**SPB Number: 2024.0101**

**EXTERIOR UPDATES**

Issued: 05/10/2024

**STANDARD PLAN BULLETIN NOTICE**  
**RaceWay Engineering and Construction Division**

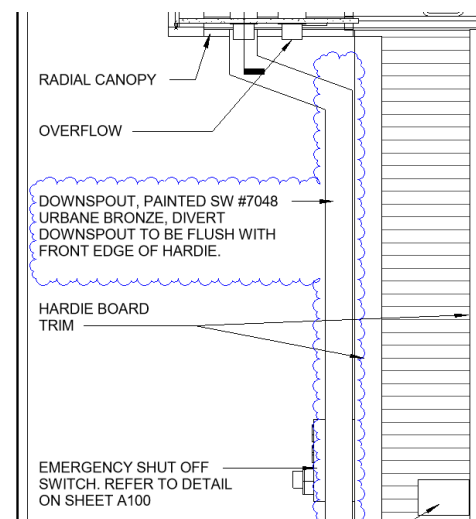
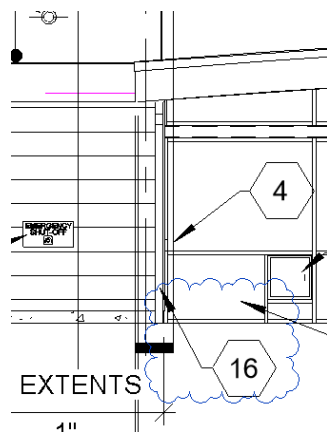
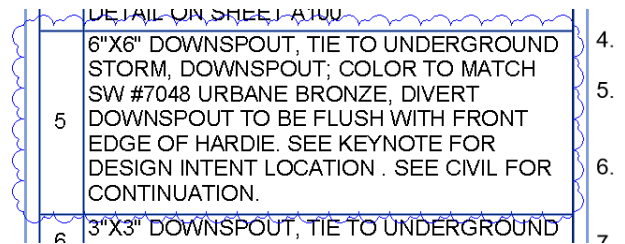
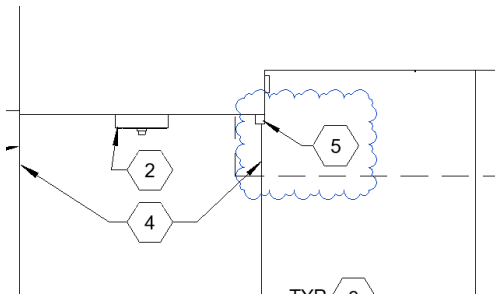
1. **DOWNSPOUT UPDATE:** Update keynote #5 on A100 to call for downspout on front elevation to be placed close to front corner of Hardie and to be painted Urbane Bronze #7048. Updated notation on section 4/A410

- Sheets: A100, A300, A410
- Attachment: A100, A300, A410

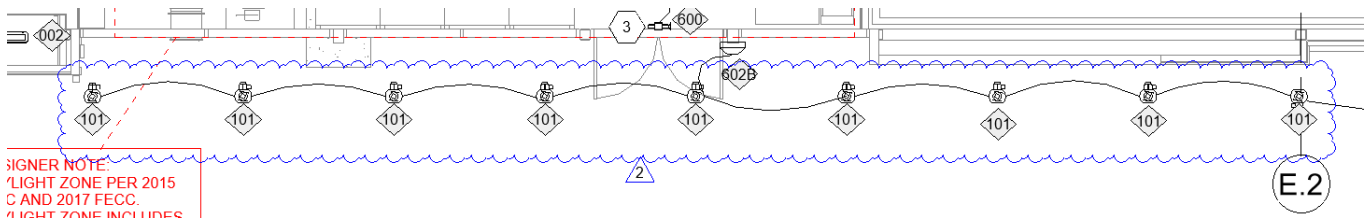
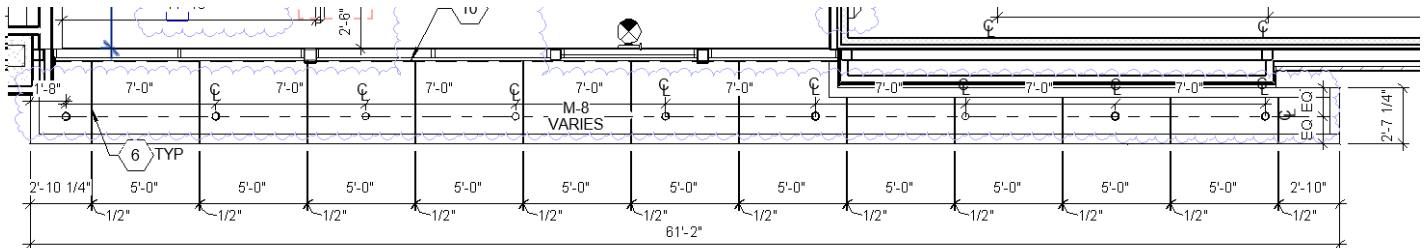
**3. FRONT BUILDING CANOPY LIGHTS:** Update locations for all lights including the addition of two lights. Adjust lights to be centered on canopy portion extending past building face.

- Sheets: A150, E150
- Attachment: A150, E150

4 VINYL SIGNAGE BLOCKING @ ACM  
 1 1/2" = 1'-0"

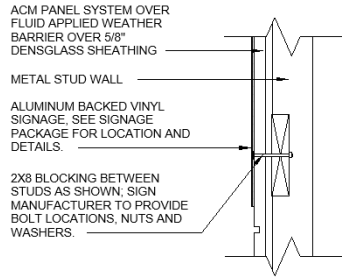
4. **'ON THE GO" SIGNAGE BLOCKING:** Add blocking behind OTG sign so aluminum sign can be mounted to the ACM.

- Sheets: A410, A420, A430
- Attachment: A430

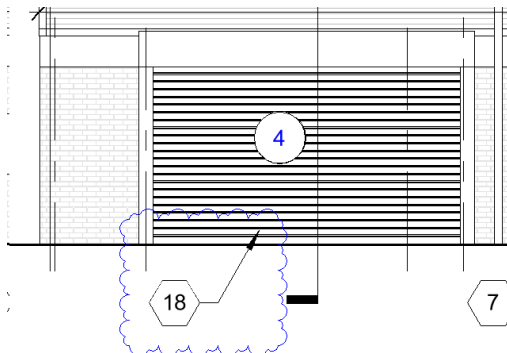
5. **CORNELL DOOR:** Paint color updated on door schedule and key note added to A300 to indicate factory painting.

- Sheets: A300, A700
- Attachment: A300, A700

18 FACTORY PAINTED DOOR; BRAKE METAL TO BE PROVIDED ALONG DOOR SIDES; SEE DOOR SCHEDULE AND A701 FOR DETAILS

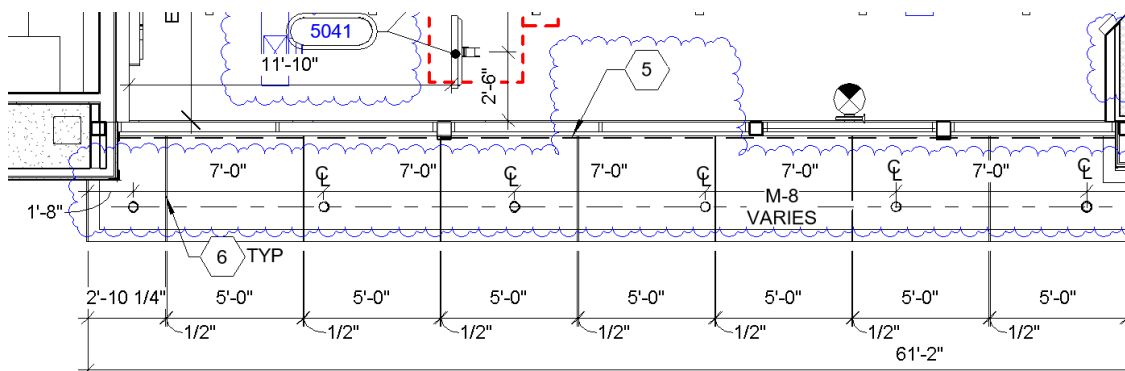
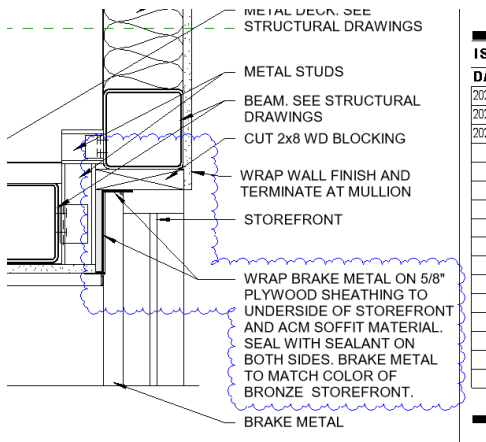
7. ACM BREAK METAL AT STOREFRONT: G.C. to provide and install a strip of bronze brake metal to match storefront to infill gap between the end of the red ACM and the storefront. Keynote #5 added to A150.

- Sheets: A150, A430
- Attachment: A150, A430

| 5 | BRONZE BRAKE METAL PROVIDED AND INSTALLED BY G.C TO INFILL GAP BETWEEN ACM CANOPY AND STOREFRONT. BRAKE METAL TO EXTEND ALONG ENTIRE LENGTH OF STOREFRONT; COLOR TO MATCH STOREFRONT. SEE 9/A430 FOR DETAILS. | 4. |
